**Development No:**

110/L002/15

<b>Application No</b>	110/L002/15
<b>Unique ID/KNET ID</b>	2015/03970/01
<b>Applicant</b>	De Young Jamestown Pty Ltd
<b>Proposal</b>	Alterations and additions to the Buffalo Restaurant – comprising a new kiosk, alfresco bar and dining area, toilet facilities, outdoor dining timber deck, boat pontoon and gangway and associated landscaping and temporary construction fence.
<b>Subject Land</b>	Adelphi Terrace, Glenelg North The proposed works include or are immediately adjacent to the existing Buffalo Restaurant and Function Centre.
<b>Zone/Policy Area</b>	Glenelg Foreshore and Patawalonga Zone Map HoB/4
<b>Relevant Authority</b>	DAC – Schedule 10(2) – Council development – (b) development that involves the construction of or change in use to a shop or office.
<b>Lodgement Date</b>	10 March 2015
<b>Council</b>	Holdfast Bay Council
<b>Development Plan</b>	Holdfast Bay Development Plan Consolidated 18 December 2014

### **1. DAC DEFERRAL – 19 January 2017**

#### **Clearer plans to demonstrate the interrelationship between the public realm and the development.**

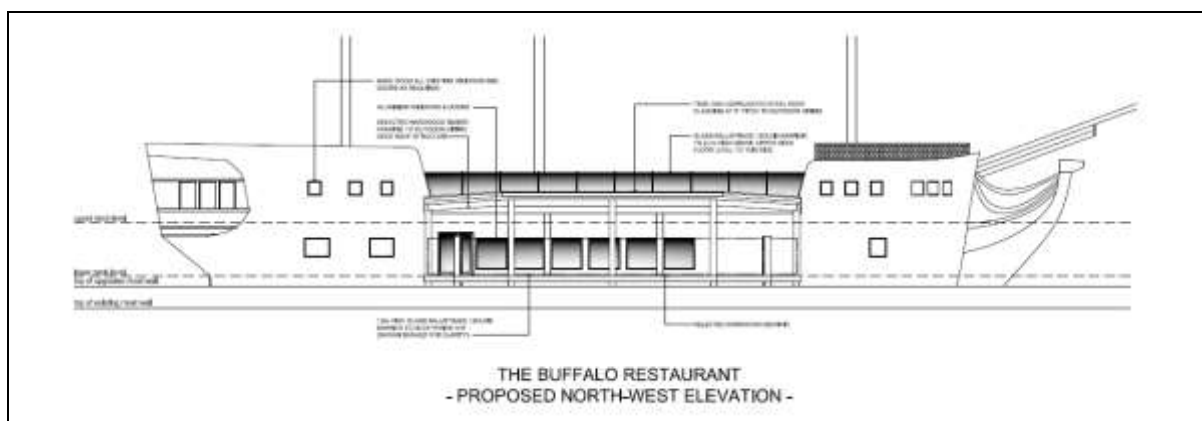
Landscape plans provided by Outer Space provide clarification on the interrelationship between the public realm and the proposal. It is noted that the lease site boundary was used to define the 'Buffalo Precinct'. The works upon this boundary aim to show a transition between the public realm and the Buffalo Precinct with the use of exposed aggregate concrete paving. Additional landscaping is also proposed to improve this space as pedestrians transition through this area.

**Details around the resolution of the moat - landscaping, water quality.**

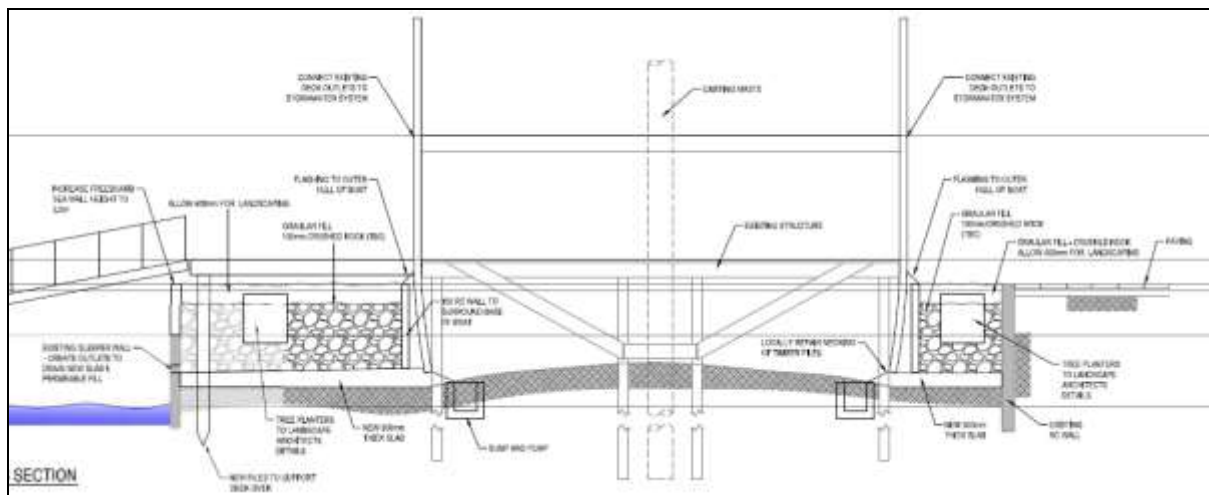
Previously plans sought to establish a rock garden and ornamental plantings around the Buffalo within the 'moat' structure. Questions from the DAC panel arose around the suitability and ongoing maintenance of this area, especially given its unsightly appearance and sunken nature.

The applicant engaged the services of an engineer to provide a suitable solution to ensure that the moat area can be managed. The solution involves the placing of a 300mm thick slab within the moat which essentially caps the existing mud bank within the moat. On top of this concrete base, crushed rock would be used to raise the inside level of the moat. Landscaping would then be established. This solution would address

any water quality concerns as it would be engineered to discharge water run-off appropriately and in accordance with relevant Australian Standards, the EPA Code of Practice, Local Government's WSUD Urban Design Manual and recognised engineering best practice.

In addition this raised platform provides opportunity to improve the amenity of the moat area, with landscaping at footpath level, with improved access to sunlight, and easier to maintain by the operators of the development.

**Identify the space, facilities and utilities that are located in the Buffalo structure that are integral to the wider development.**

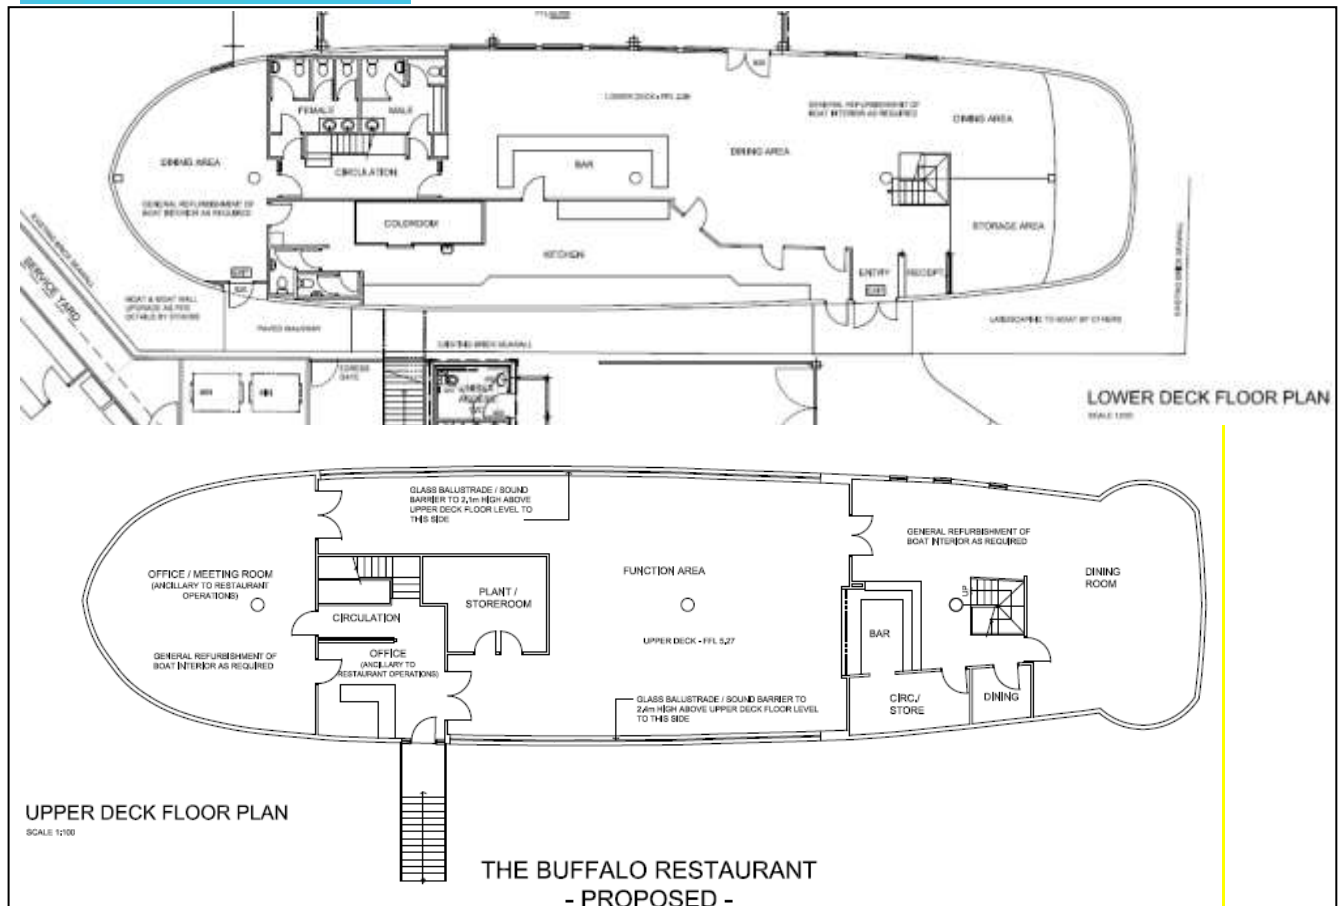
Plans have now been provided which show the internal layout of the Buffalo Structure. These internal spaces would comprise bars, dining areas, kitchen, amenities, function spaces, office/meeting room, storerooms and cold-room.

Generally, the internal layout would largely remain the same, although the structural supports of the Buffalo would allow future modification if required. Internal works predominantly involve ensuring the structure is brought up to specification with the most recent Building Rules Requirements.
